Access Compliance Report

Public Rights-of-Way

(Curb Ramps)

Intersection ID: 5468	Main Street: N_TRYON_ST	Cross Street: J_W_CLAY_BV	Location:	E
ADA ID: F2AFC938085A	Ramp Type: Perp	Initial Pass/Fail: Fail	Overall Compliance: No	Severity Score: 10
Codes/Mitigation Info/Possible Solution		Field Measurements/Component Compliance

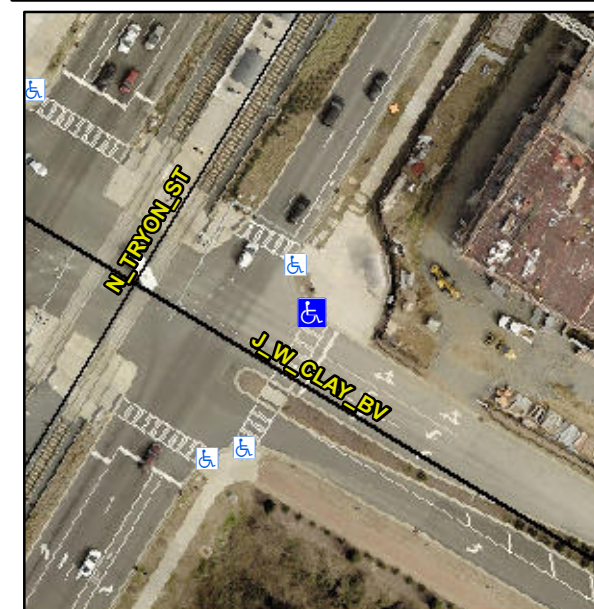
Not Found, R304.5.1

Compliance	Description	Data	Compliance	Description	Data
N/A	Ramp Length (in)	98.5	Yes	Ramp Slope (%)	7.9
No	Ramp Width (in)	47.5	Yes	Ramp XSlope (%)	2.6
N/A	Flare Type LT	N/A	N/A	Flare Type RT	N/A
N/A	Flare Slope LT (%)	N/A	N/A	Flare Slope RT (%)	N/A
N/A	Flare Traversable LT?	N/A	N/A	Flare Traversable RT?	N/A
N/A	Landing Length (in)	N/A	N/A	DWS Provided?	N/A
N/A	Landing Width (in)	N/A	N/A	DWS Contrast?	N/A
N/A	Landing Slope (%)	N/A	N/A	DWS Length (in)	N/A
N/A	Landing X Slope (%)	N/A	N/A	DWS Full Width?	N/A
N/A	Landing Curb? (Y/N)	N/A	N/A	DWS Offset (in)	N/A
N/A	Shared Landing?	N/A			
N/A	Gutter Ponding?	N/A	N/A	Gutter Slope (%)	N/A
N/A	Gutter Lip Ht (in)	N/A	N/A	Gutter X Slope (%)	N/A
N/A	Painted X Walk1?	No	N/A	Painted X Walk2?	N/A
	X Walk 1 Direction	To SW		X Walk 2 Direction	N/A
N/A	X Walk 1 Width (in)	N/A	N/A	X Walk 2 Width (in)	N/A
	X Walk 1 Slope (%)	2.3		X Walk 2 Slope (%)	N/A
	X Walk 1 X Slope (%)	3.7		X Walk 2 X Slope (%)	N/A

Remove & Replace Entire Ramp.
